Commonwealth Edison

Subject: Zion Station Units 1 and 2
I.E. Bulletin 80-04,
Main Steam Line Break with
Continued Feedwater Addition
NRC Docket Nos. 50-295 and 50-304

ATTACHMENT

CONTAINMENT PRESSURE RESPONSE FAILING A MSLB

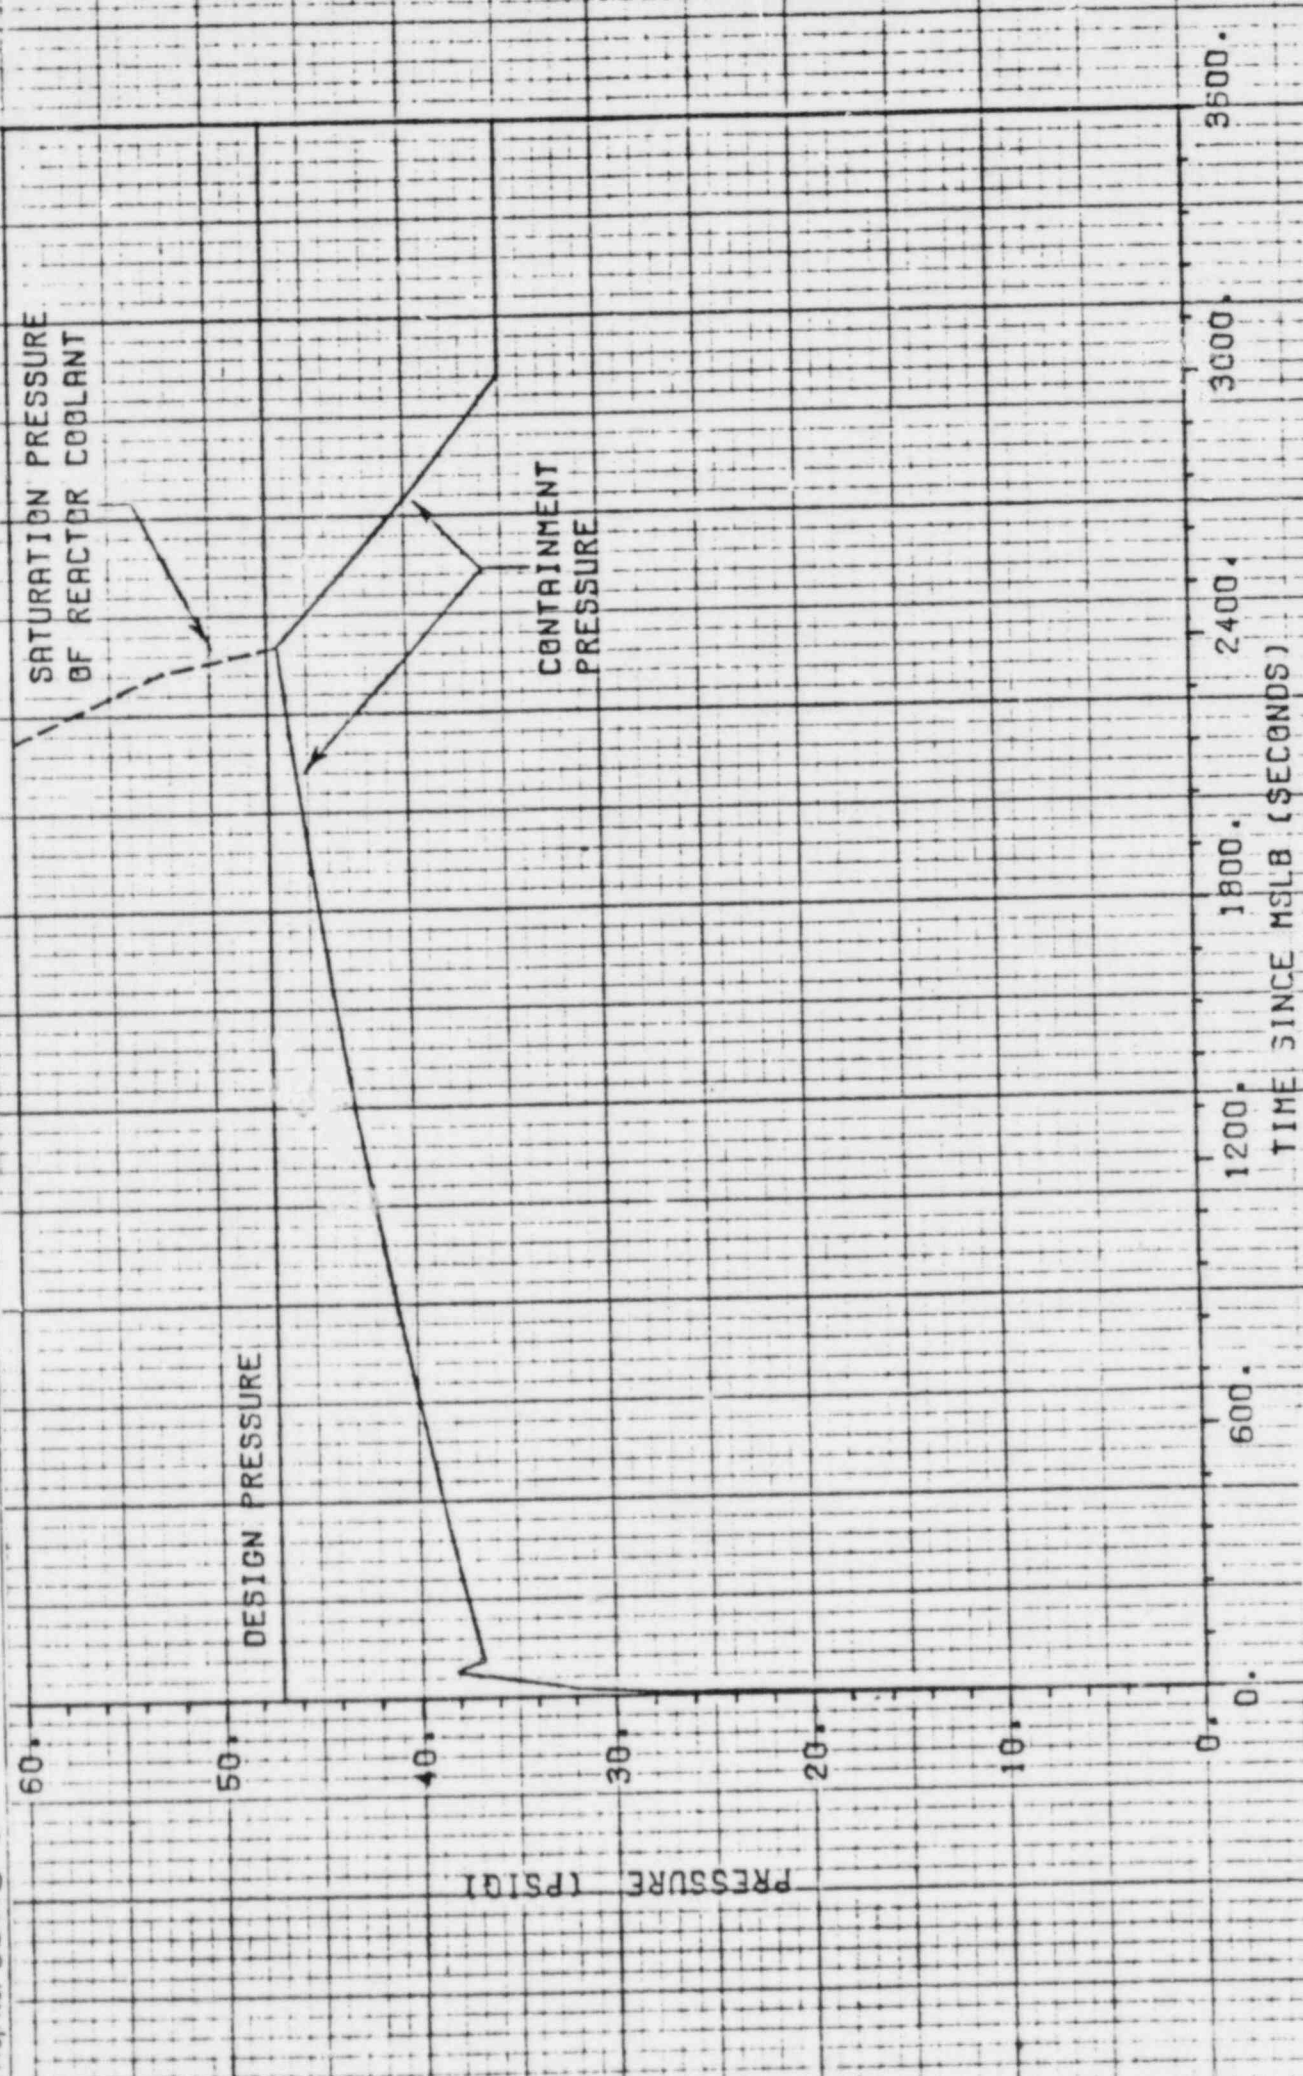
1. When will containment design pressure be exceeded (i.e., number of minutes after the start of a MSLB) if no operator action is taken to terminate the accident? This determination should be made for both throttled AFW flow and runout AFW flow, since a single active failure (e.g., operator error) could cause an improper throttle setting.
2. Provide the magnitude of the peak pressure and the time at which the peak occurs, for both cases of throttled and runout AFW flow.

The containment pressure response is shown in the attached Figure. The containment pressure reaches a maximum value of 46.5 psig at 2405 sec., which is below the containment design pressure of 47 psig.

It should be emphasized that this result is conservative, due to the conservative assumptions regarding the heat sources available for steam generation, minimum containment safeguards capability, and the times required for component actuation. It should also be noted that in the Zion Probabilistic Safety Study, the actual containment pressure capability was determined to be 149 psig. (reference 5)
